**Review of the Rocky Flats Plant Special Exposure Cohort (SEC) Petition,
SEC-00030**

Supplemental Report on Neutron Doses at Rocky Flats, 1952 to 1970

**Contract No. 200-2004-03805
Task Order No. 5
SCA-SEC-TASK5-0052, Supplemental Report**

April 30, 2007

Figure 1: Neutron Dose versus Percent Notional Dose, 1955

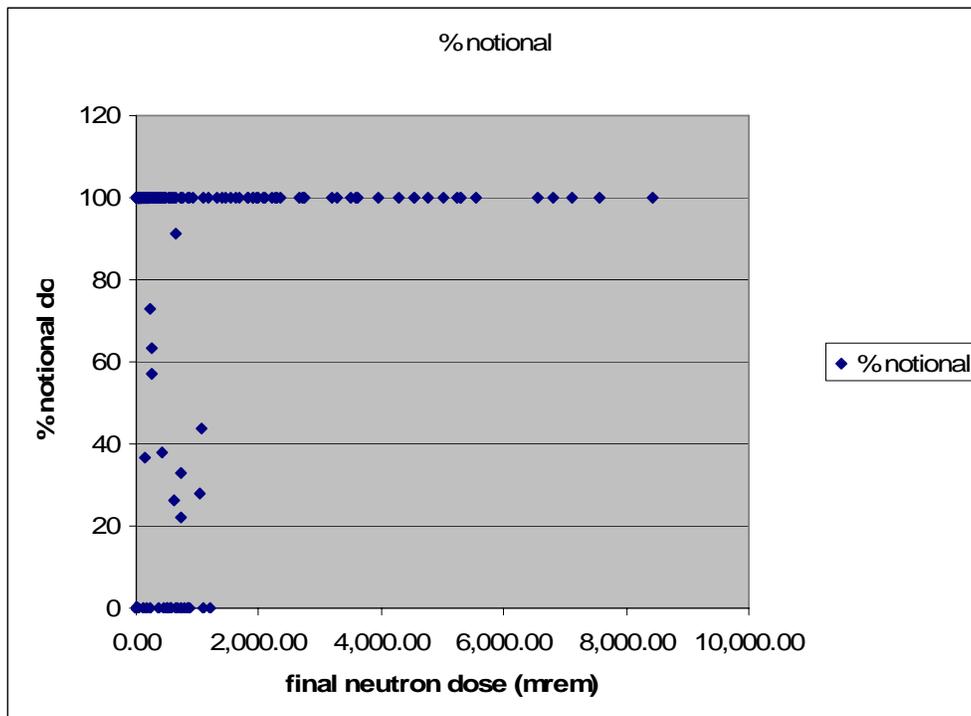
Figure 1 shows the scatter plot of percent notional dose versus the total estimated neutron dose for 1955. It is clear that for this year, the highest estimated doses were systematically among those who were not monitored at all during that year—that is, those who had 100% notional doses. As discussed below, notional doses for the 1952–1958 period were estimated from 1959 monitoring data. Again, given the questions regarding the estimation of notional doses, this comparison does not yield definitive results.

Figure 2: Neutron and Gamma Dose Scatter Plot, 1959, with a Non-forced Linear Regression shown (“linear neutron”)

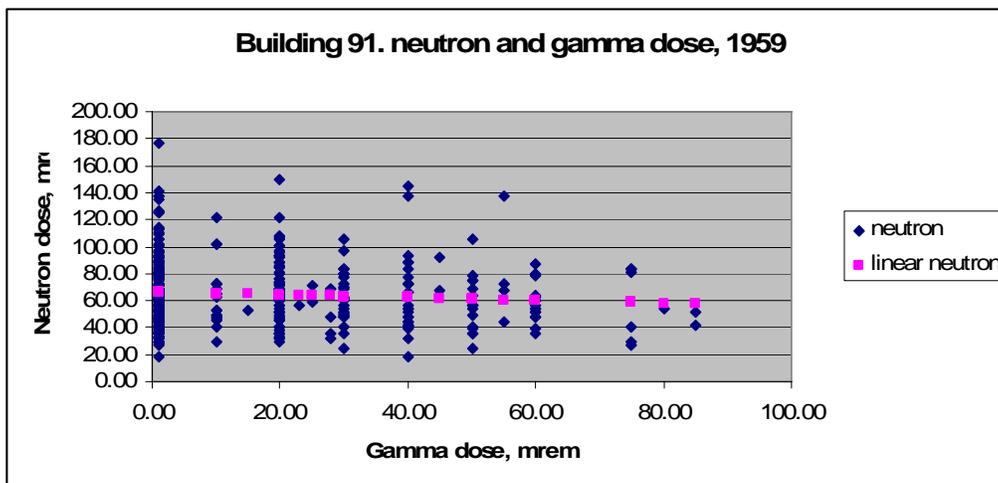
Building 91 badges were issued monthly during 1952 to 1956, and also during 1959. Figure 2 shows a scatter plot of Building 91 paired neutron and gamma 1959 data (zero gamma doses are set equal to 1, following the NDRP practice). A linear regression line (non-forced) is also shown. It is clear that individual neutron doses are uncorrelated with the corresponding gamma doses ($r^2 = 0.007$). A very nearly constant value of about 60 mrem per badge, independent of the gamma dose, is returned by the linear regression (the intercept is about 66 mrem).

Figure 3: Neutron and Gamma Dose Scatter Plot, 1952, with a Non-forced Linear Regression shown (“linear neutron”)

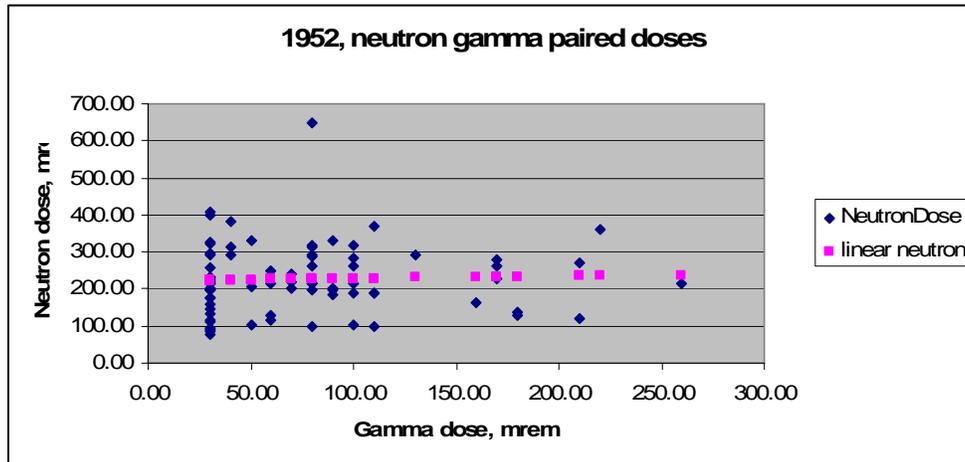
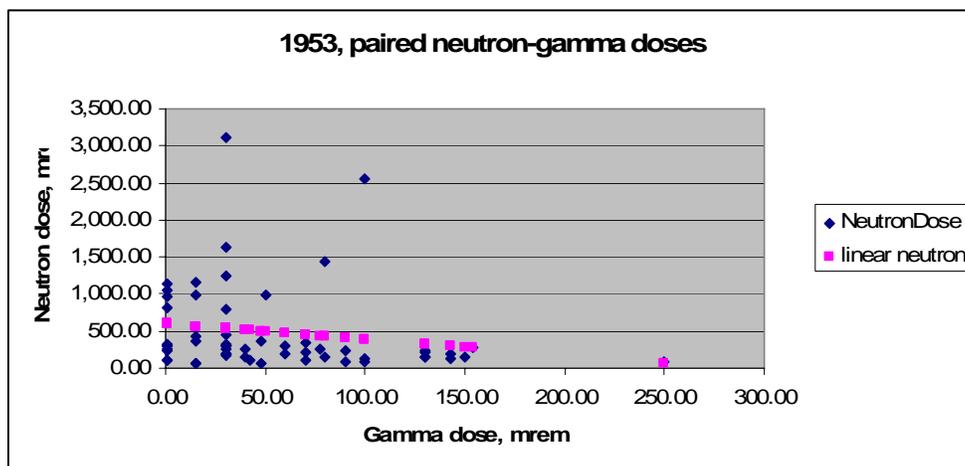
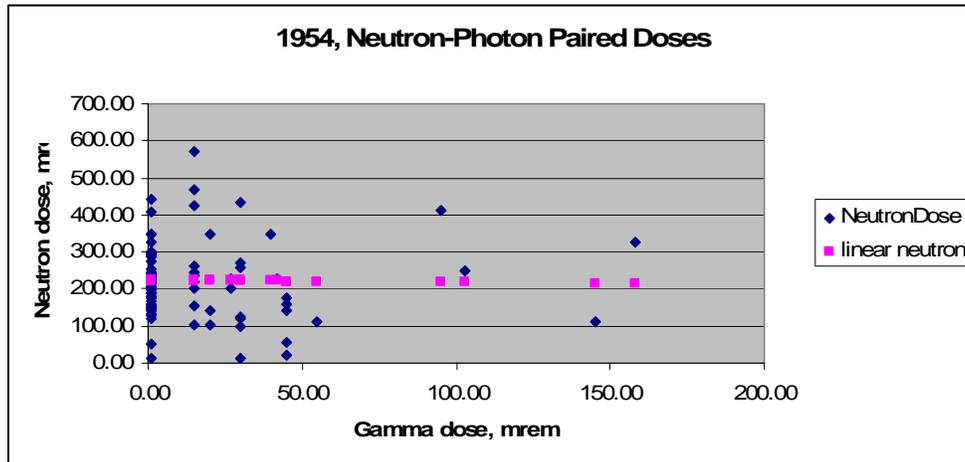
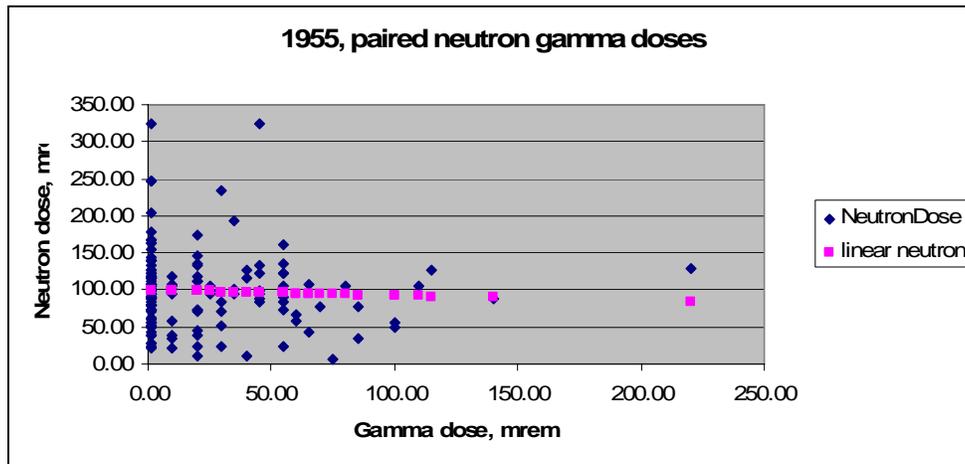
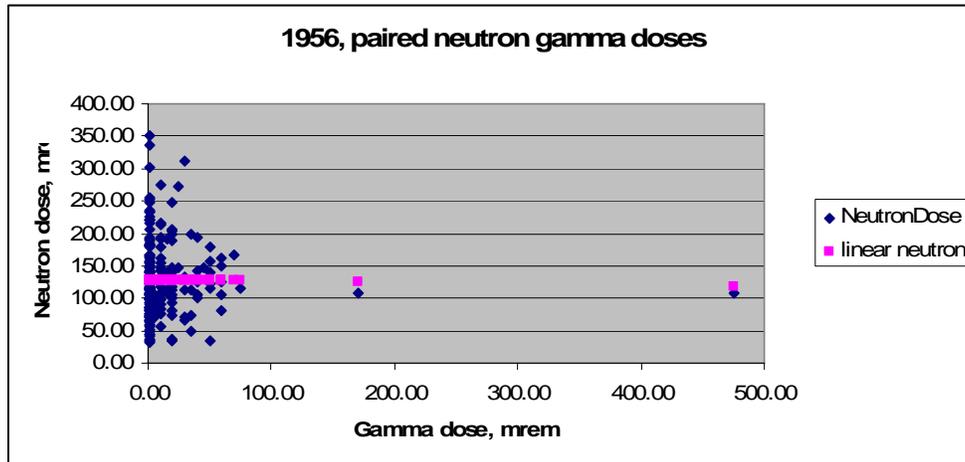
In addition, the data for 1952 to 1958 generally show a lack of correlation between neutron and gamma doses. Figures 3 through 7 show scatter plots of the paired neutron and gamma data and the corresponding regression lines. Except for 1953, where there is a slight negative correlation ($r^2 = 0.035$), the individual neutron and gamma badge readings are essentially uncorrelated, with $r^2 \ll 0.01$ in all cases.

One feature of these plots that is important for a comparison of working conditions is the typical neutron readings for individual badge cycles (all of them being about 1 month). The readings show a wide variation over the period, with the highest individual readings occurring in 1953, followed by 1952. Generally, the lower readings per badge cycle occur in 1959.

Figure 8: 1959 Matched Pairs for Building 71

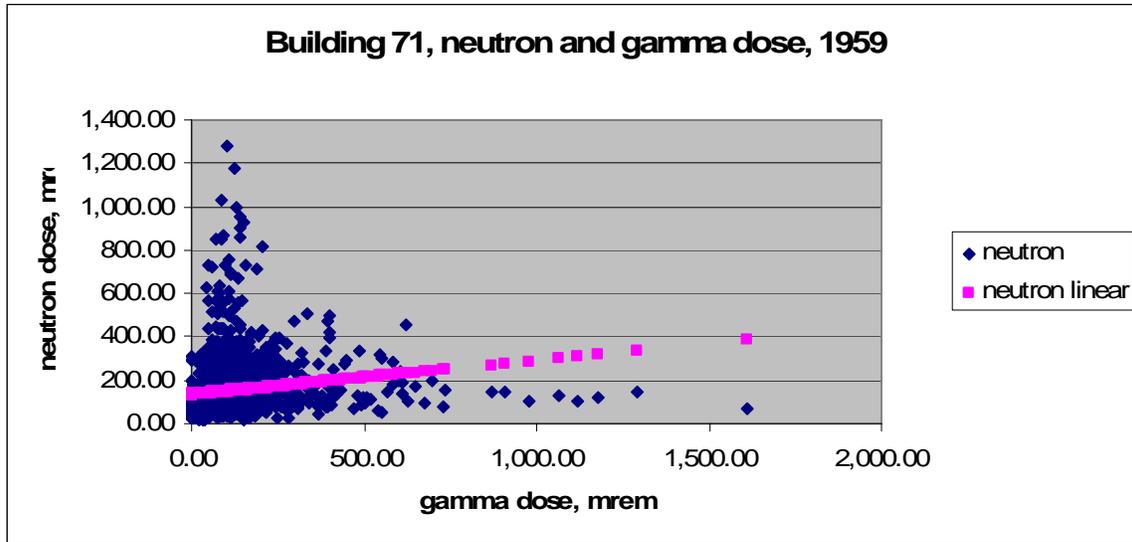
A study of the ratios of paired daily neutron and exposure rates would be needed to determine if there are distinct job categories, so far as n/p ratios are concerned. This would appear to be a prerequisite to determining the validity of using a building n/p ratio for estimating individual notional neutron dose. The NDRP did not carry out such an analysis. It did consider several approaches and selected building n/p ratios. The averaging of job types is implicit in such a selection, and there is a potential for underestimating dose for some groups of workers, notably those in situations with relatively high neutron dose rates and low gamma dose rates. Paired neutron-gamma data make it clear that such situations were quite common. Figure 8 shows such paired data for Building 71 for 1959. A linear regression line is also shown (though the correlation is poor, $r^2 = 0.025$).

It is clear that a low gamma dose (less than LOD) could be accompanied by high neutron doses of a few hundred millirem even in a single badge cycle and vice versa.

Moreover, non-forced linear regressions generally show a substantial intercept (see Figure 8), indicating a positive neutron dose when the gamma dose is zero. Hence, the NDRP model does

Figure 9: Percent Notional Dose compared to Total Neutron Dose Estimate, 1959

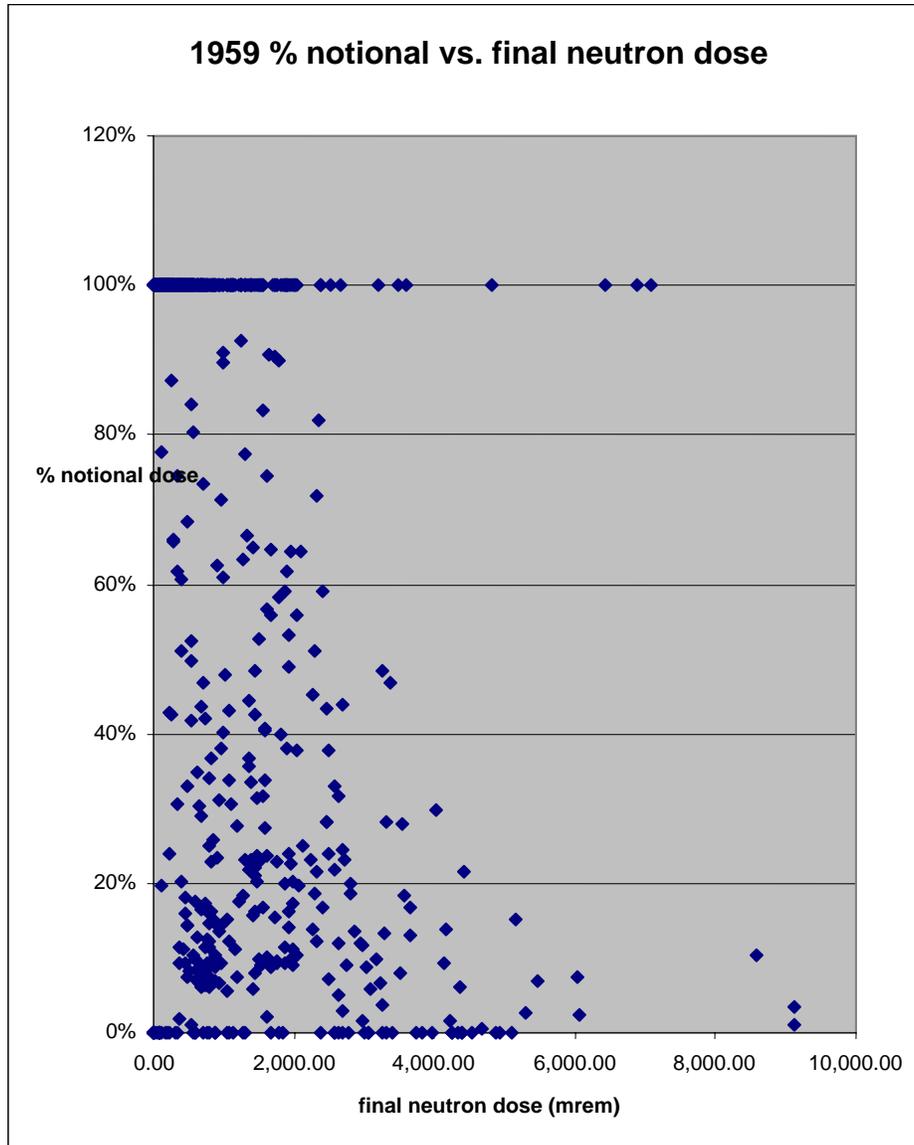
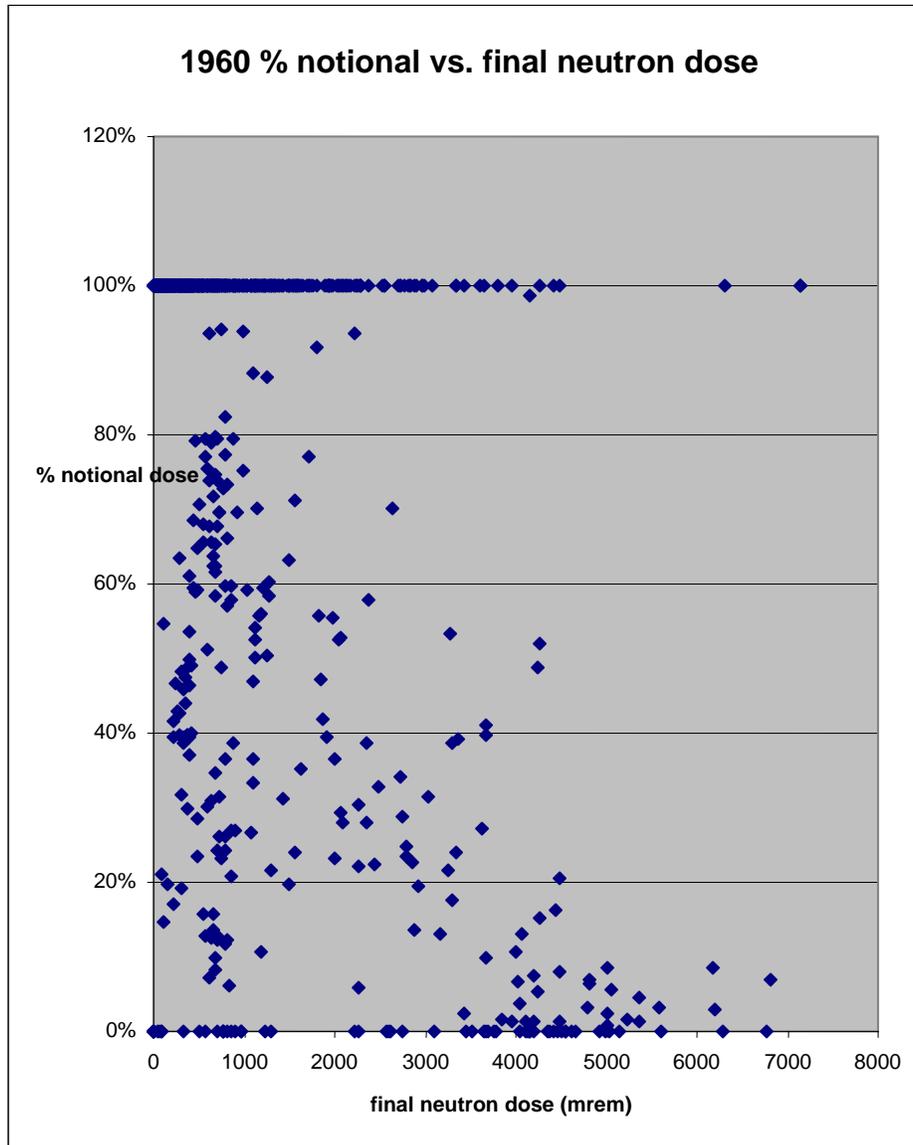
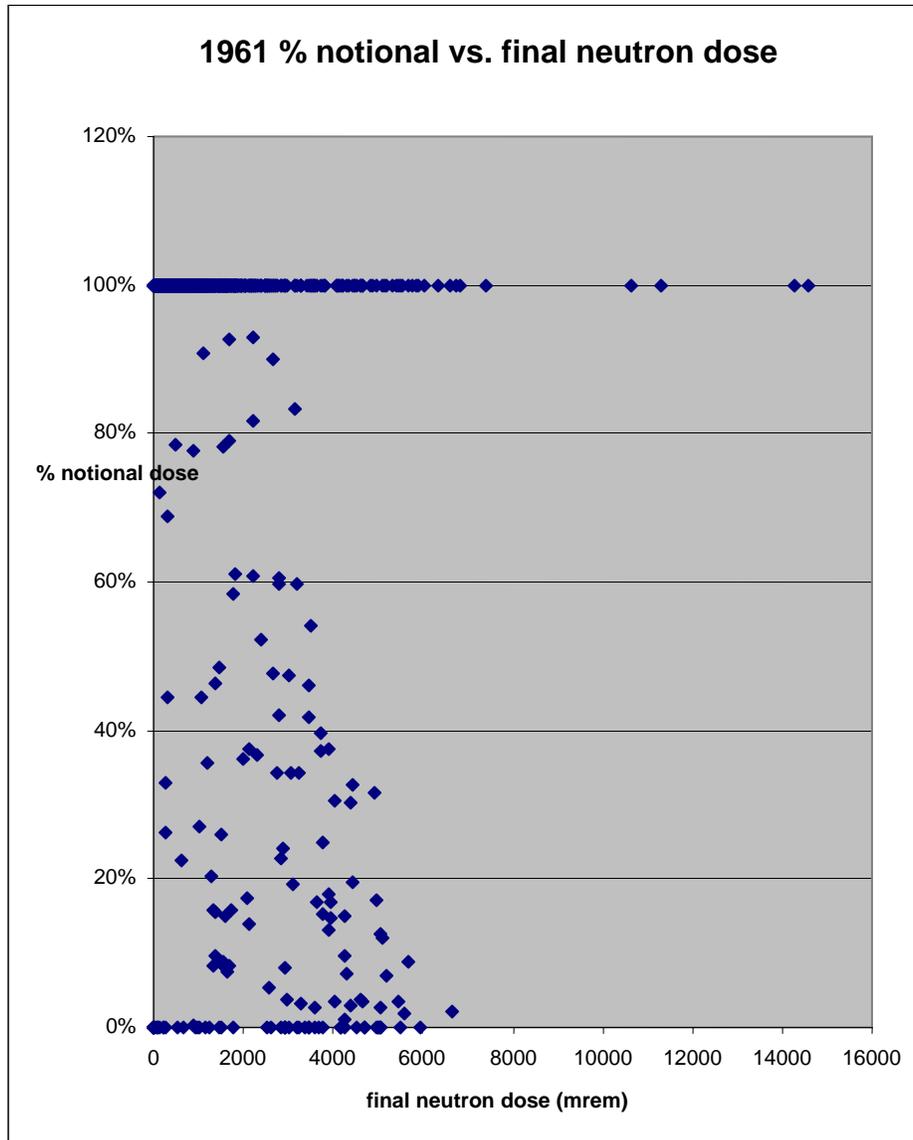
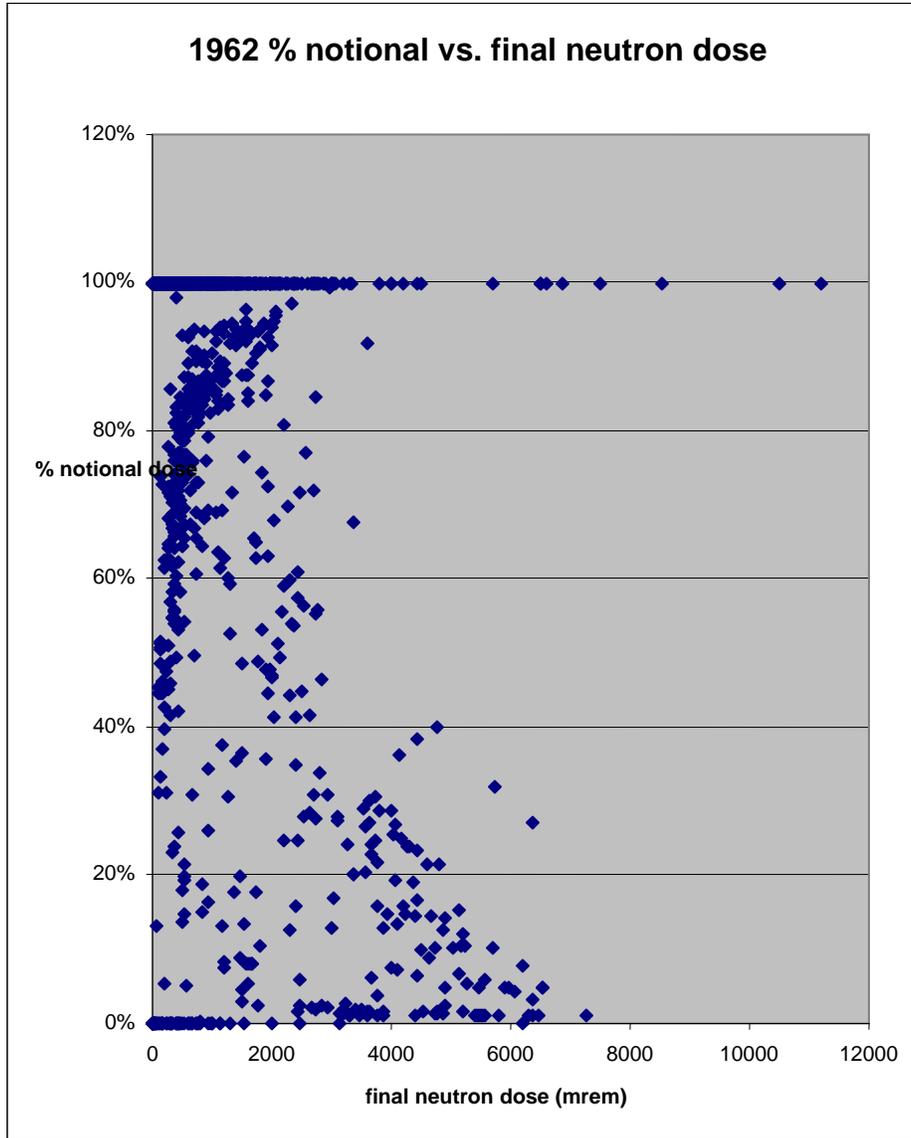
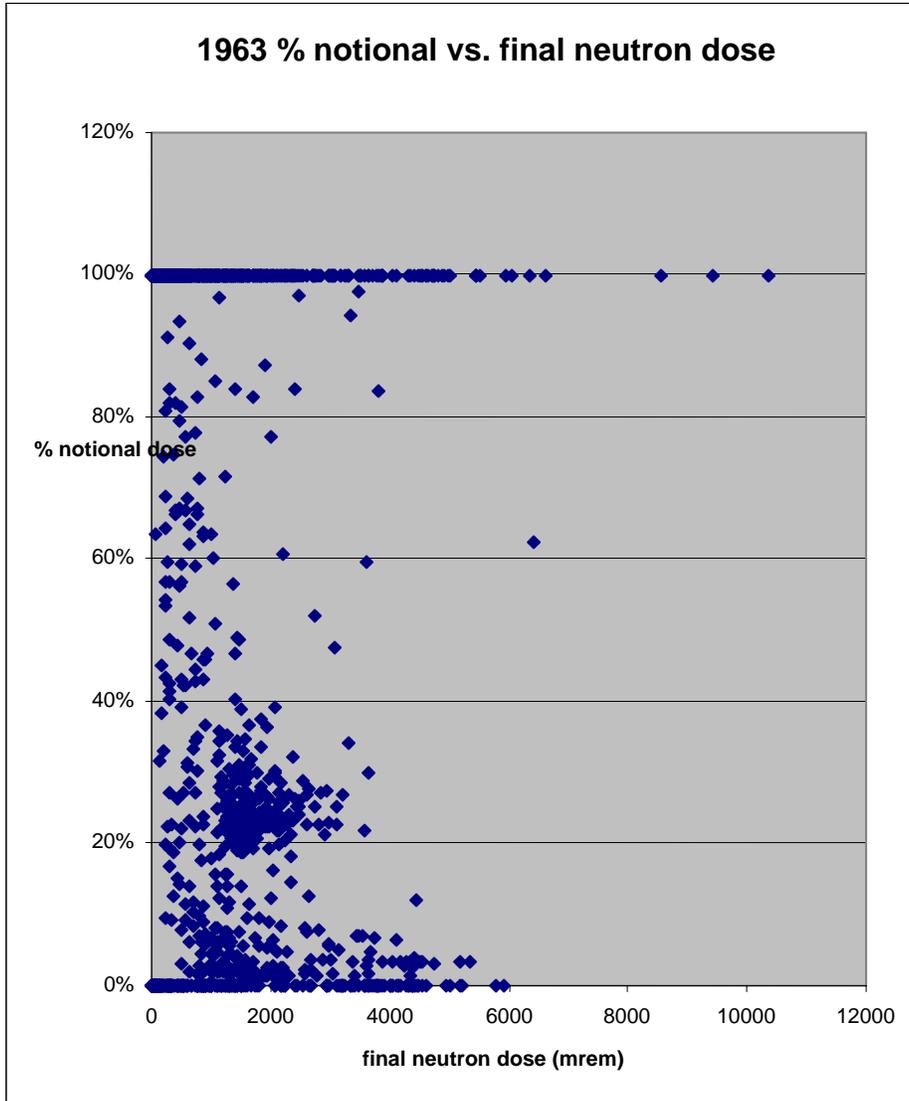
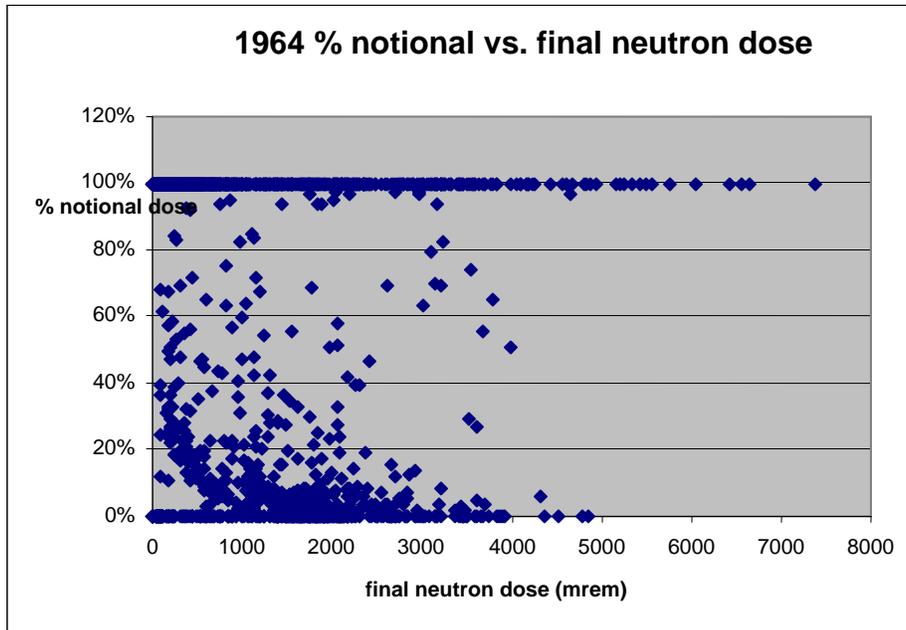
The notional dose estimates with the largest element of uncertainty are the ones that are estimated entirely or almost entirely from a building n/p ratio. This proportion of workers in this category varied by year. Since monitoring coverage took a sharp jump in 1964, the coverage from 1965 onward would be expected to be better. Figures 9 through 14 show that for most years from 1959 to 1964, a large number of workers had their entire neutron dose estimated from

a building n/p ratio, including those with the higher estimated doses. In 1959 and 1960, the results were more mixed.
